## QUALITY ASSURANCE -- NON-CONFORMANCE REPORT

**Report No:** NCR-000257

**NCR #:** ZPMC-0231

**Reference Description:** Missed MT Indications by QC

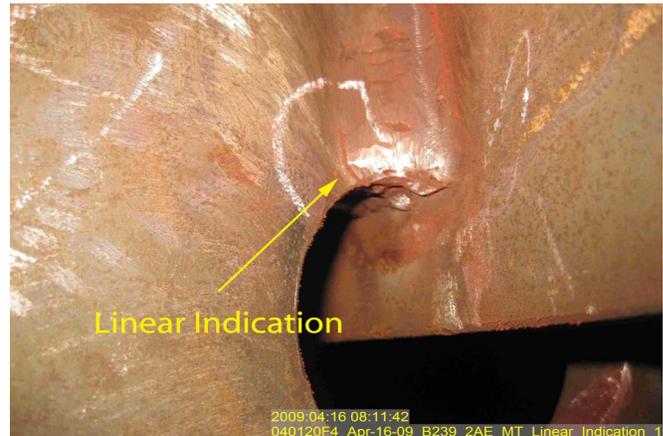
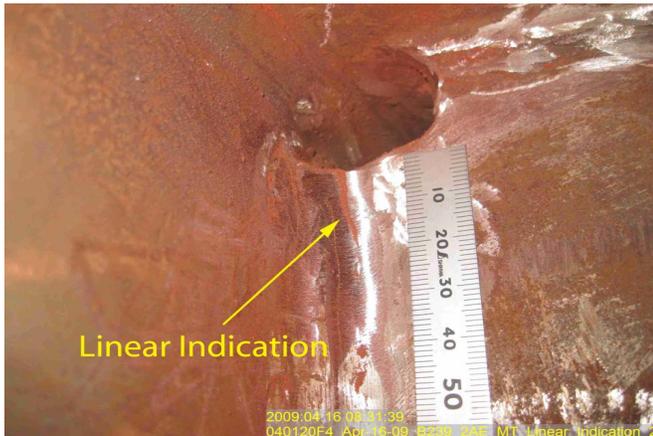
During random verification Magnetic Particle Testing (MT) of open rib deck stiffener to the corner assembly floor beam web plate (weld numbers SSD56-PP14.5-141,137, SSD17-PP15-142 and CSD10-PP14.5-073), Caltrans Quality Assurance (QA) Inspector discovered a total of four (4) longitudinal linear indications from 10 to 20mm in length. These linear indications were not found when the Contractor performed 25% MT inspections.
